City of Santa Cruz

**DOWNTOWN
~~RECOVERY~~ PLAN**

As Amended through _____ 2017

This document shows changes made to the July 21, 2016 version with strike-over and underlined text. Yellow highlights indicate modifications from the August 18, 2016 Planning Commission meeting.

Figure H-1: Proposed distribution of additional height for sites 2015,000–50,000 sq. ft. Proposed distribution of additional height for sites larger than 50,000 sq. ft.

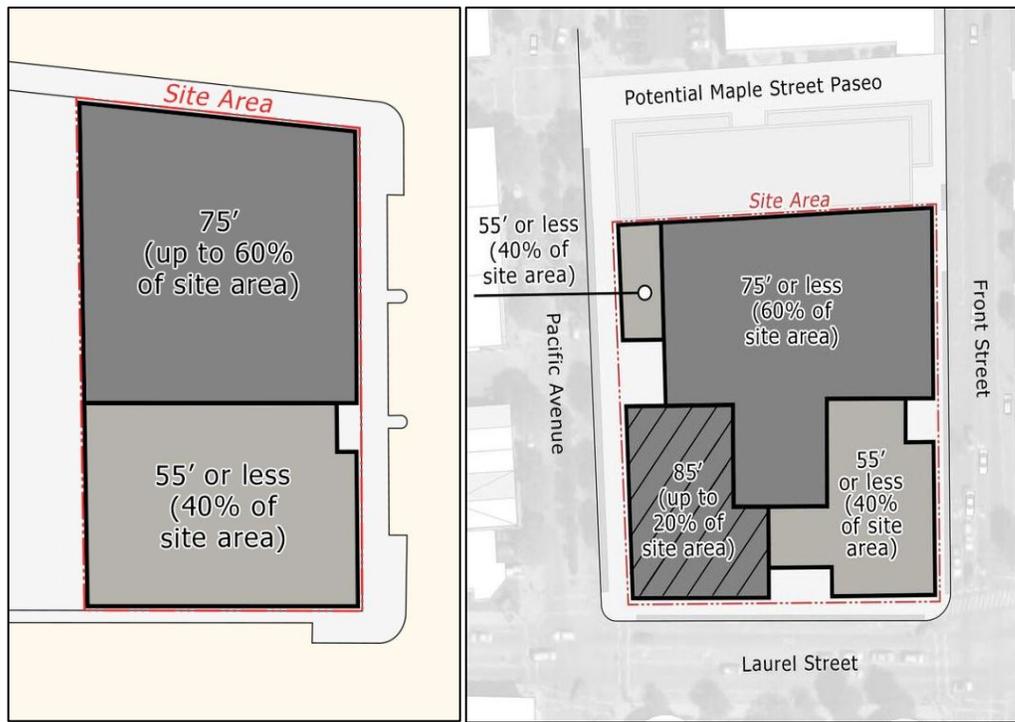
- i. Maximum Height and Footprints. For sites which are eligible for additional height, the footprint of portions of the building at or below 55 feet shall be at least 40% of the total site area; portions of the building footprint above 55 feet to a height of 75 feet may comprise up to 60% of the site area. For assembled sites greater than 50,000 square feet in area, buildings may achieve an ~~85~~foot height for up to 20% of the total site area. (See Figure H-1)

Figure H-2: Example of possible distribution of frontage heights along Pacific Avenue and Laurel Street.

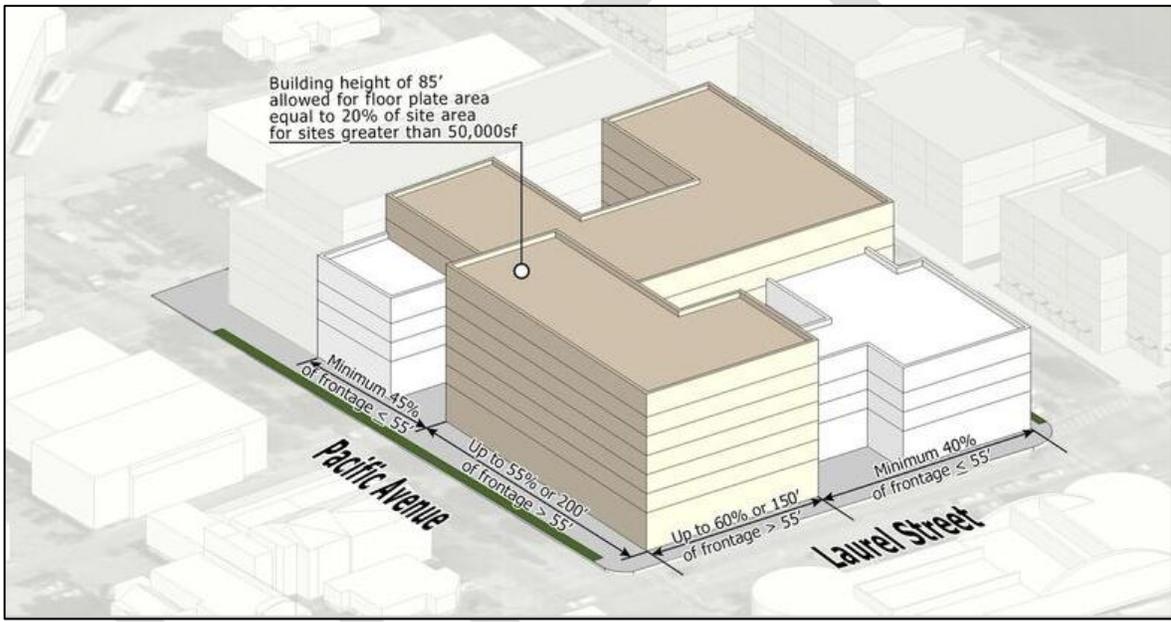
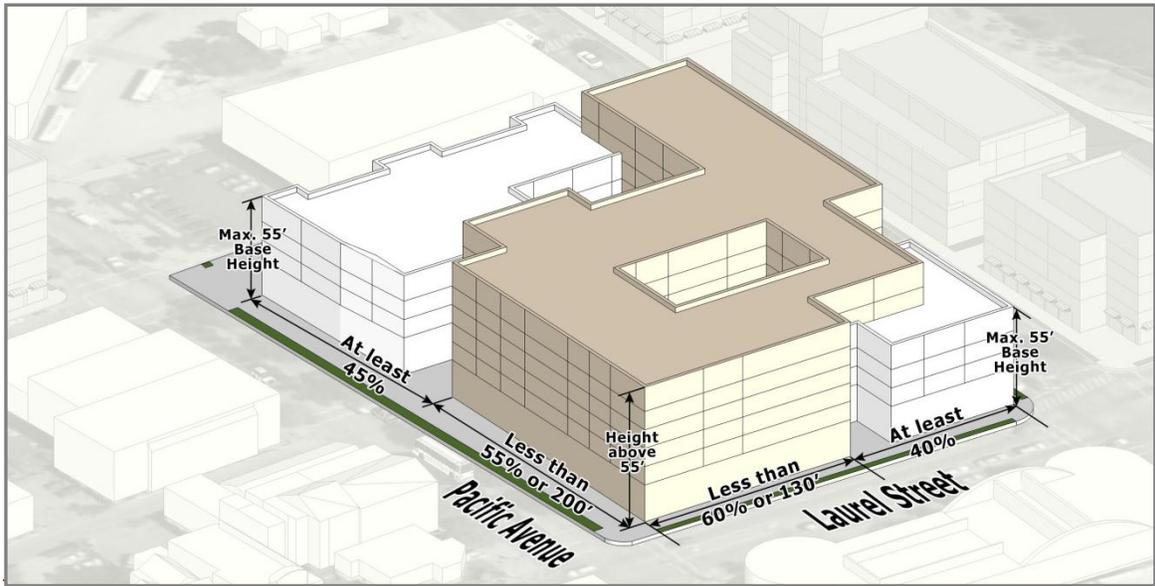
- v. Laurel, Cathcart and Soquel Building Lengths. Along Laurel Street, Cathcart Street and Soquel Avenue, portions of buildings that exceed the maximum base height of 55 feet may occupy up to 60% of the length of the property line or 130-150 feet, whichever is less. Any additional height above the base height must be set back from the building wall by at least 25-15 feet. (See Figure H-2)
